Product Revision Change Notice

Date: 4/24/19
Product Description: Synrad 48 Series high performance CO₂ lasers
Product P/N: 48-1, 48-2
Description of Change: Modified cover mounting hardware
PCN#: 001-2019
ECO#: 10812

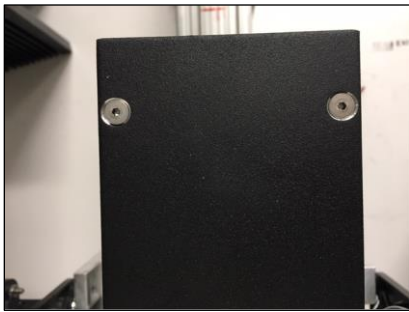
- The mounting holes in the bottom cover will be modified from countersunk holes to slots. The new mounting hole style in the bottom of the cover is shown in the following picture:
